**CITY OF TEMPE
DEVELOPMENT REVIEW COMMISSION**

**Meeting Date: 03/03/2015
Agenda Item:**

ACTION: Request for Development Plan Review of a new sanctuary and parish house for Iglesias De Dios Pentecostal Church located at 906 South George Drive. The applicant is Rene Rivera, 3R Construction Group.

DPR14132 Development Plan Review including site plan, building elevations, and landscape plan

SITE PLAN

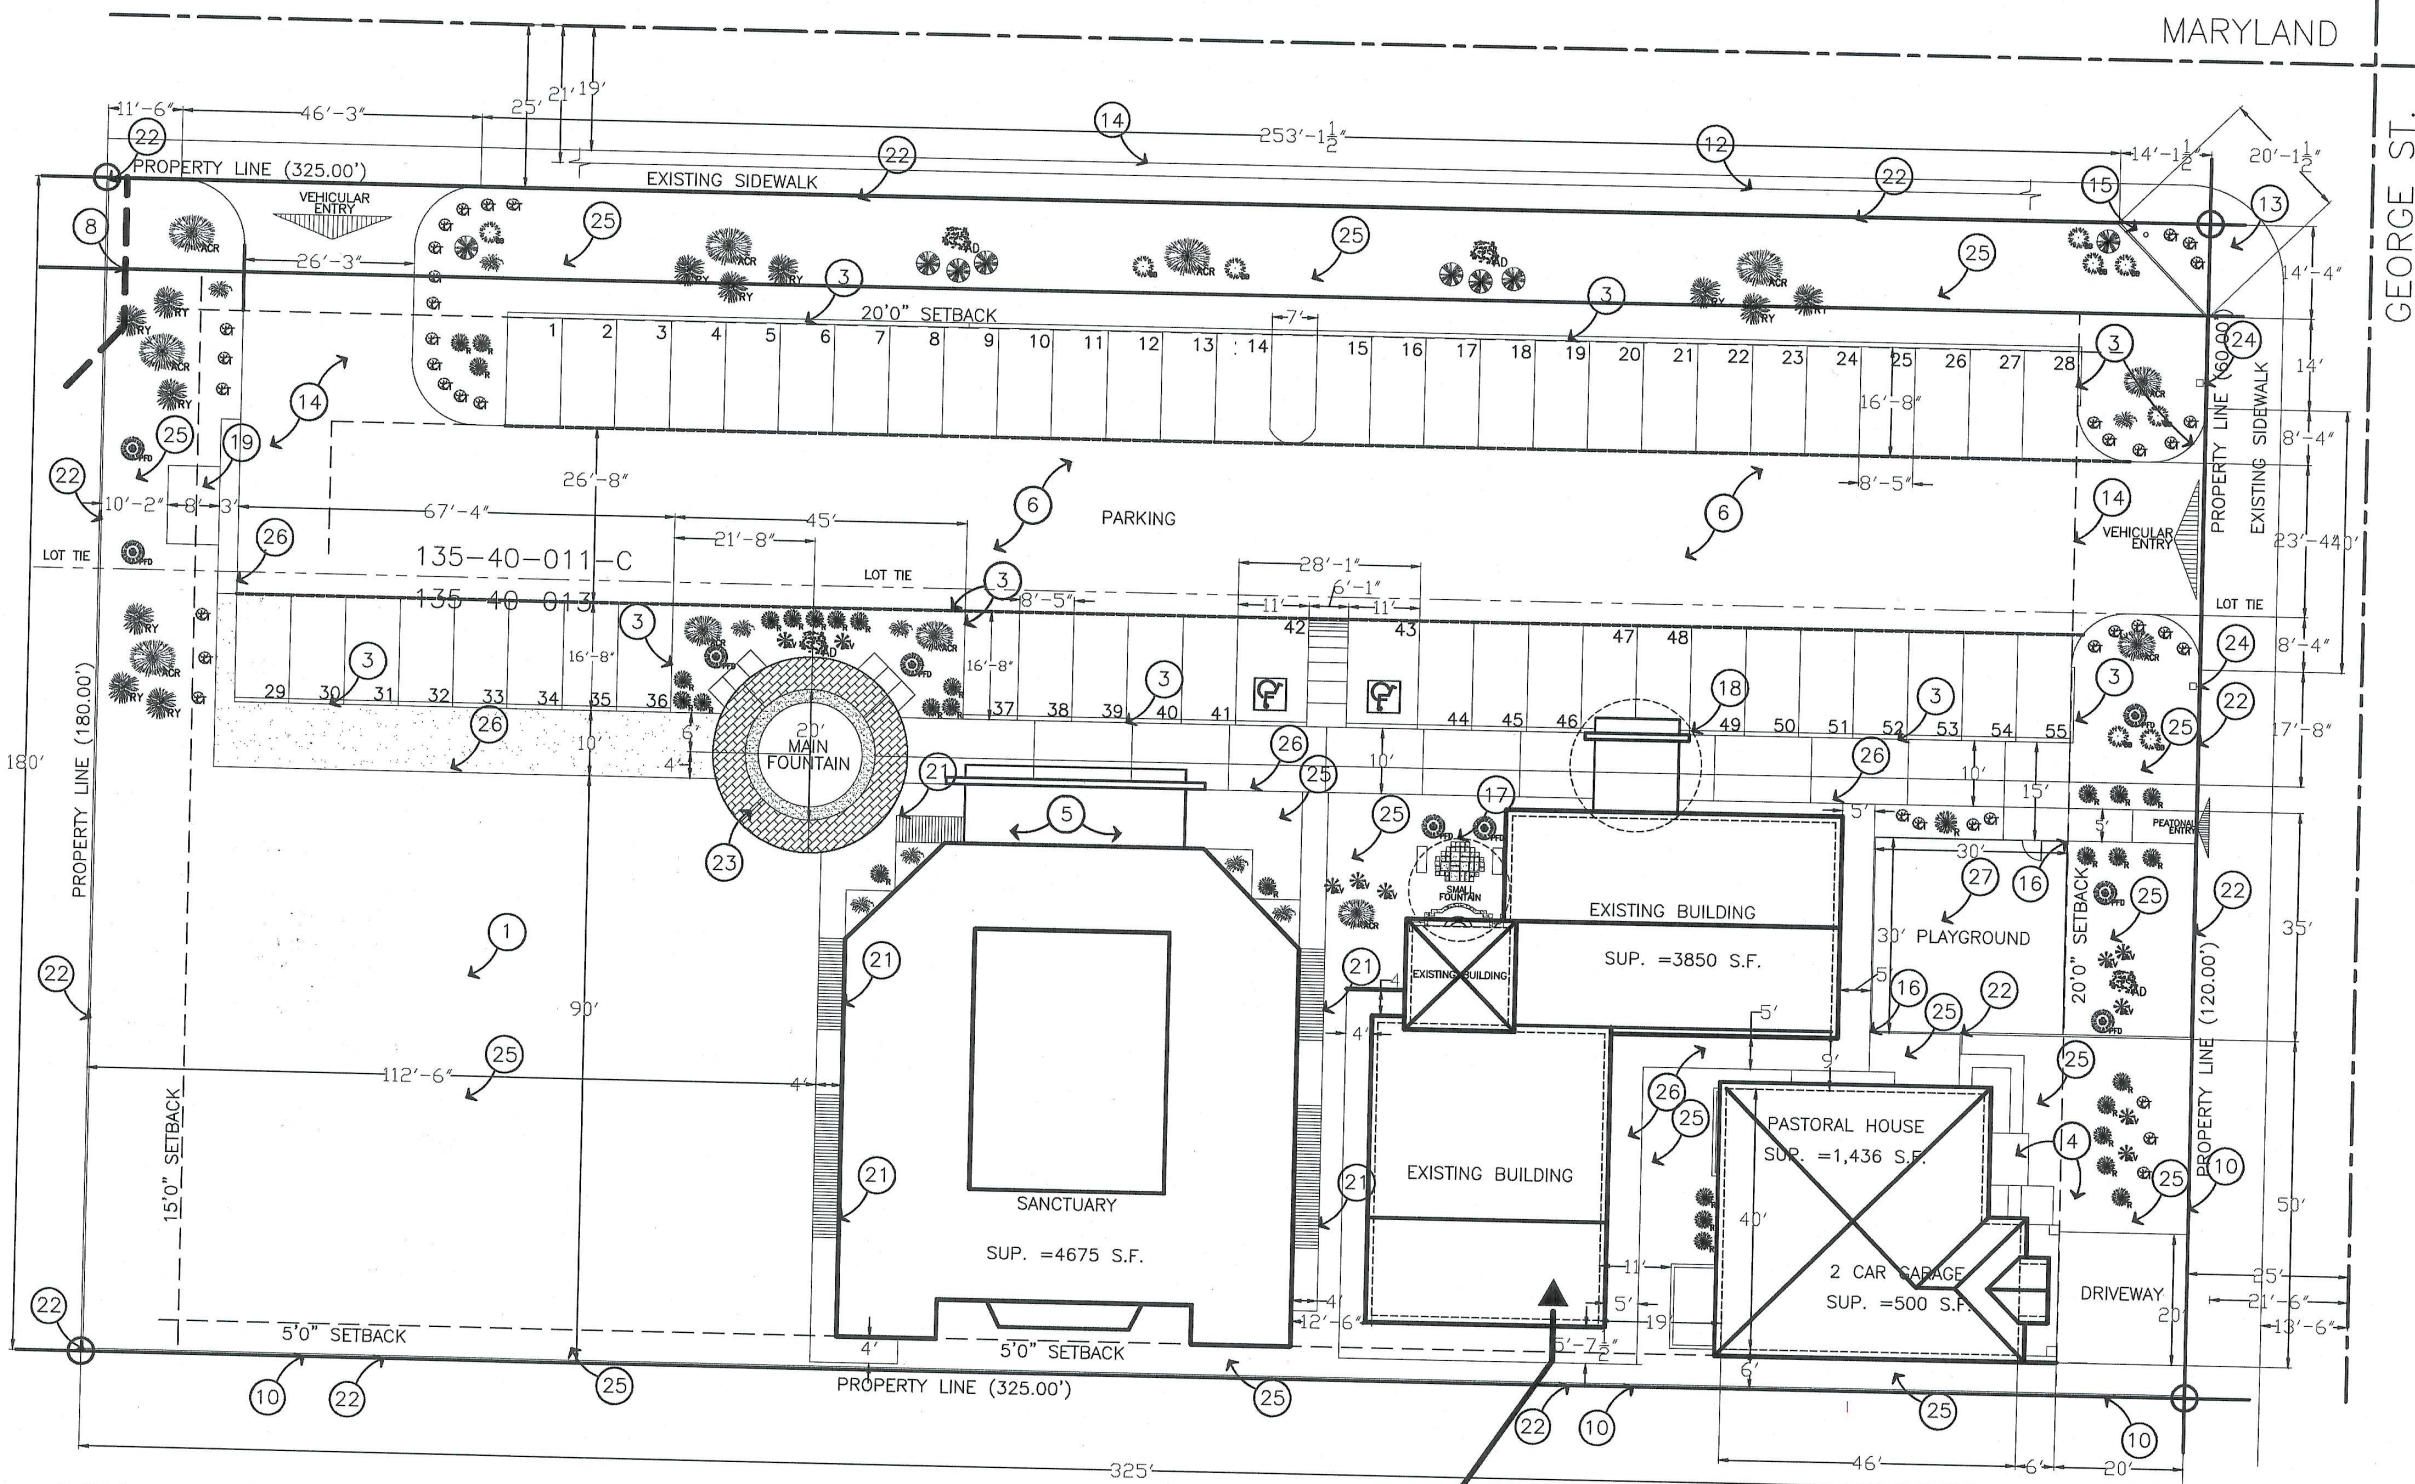
The current site is very sparse of landscape material. Enhancement of landscape elements on site, include the addition of a variety of 2' and 3' shrubs. No canopy trees are shown along the street frontage or in the parking areas. The final landscape plan to be reviewed in as part of the plan check. Show the required trees along the street frontages (in a quantity of 1 per 30 lineal feet) and trees in the parking lot landscape areas. As a supplement to buffering trees on the west and south property lines are enacted by conditions of approval.

2. Replace any chain link used on plan with ornamental iron.
3. Construct the enclosure in accordance with standard detail DS-116 except use slump block concrete masonry units that match the buildings.
4. Locate a required, minimum 7'-0" wide Landscape Island at 15 parking space intervals. Consider locating adjacent to ADA spaces to service as one of the islands.
5. Show bike parking adjacent to the entrance to sanctuary, on a concrete pad and not in landscape areas or impeding pedestrian flow.
6. Finish utility equipment boxes for this development in a neutral color (subject to utility provider approval) that compliments the coloring of the buildings. Do not paint over warning decals or other identifiers on utility boxes.
7. Place exterior, freestanding backflow assemblies in pre-manufactured, pre-finished, lockable cages (one assembly per cage).

13. Provide one thorn less canopy tree of 24" box installation size in each required landscape island. Provide five ground covers per each required landscape island.

14. Provide upright tree buffer of minimum 24" box installation size along the west property line. Space trees at approximately 25'-0" on center.
15. Supplement landscape plan with fourteen canopy trees of minimum 24" box installation size. Trees may be clustered along the length of the two street frontages.
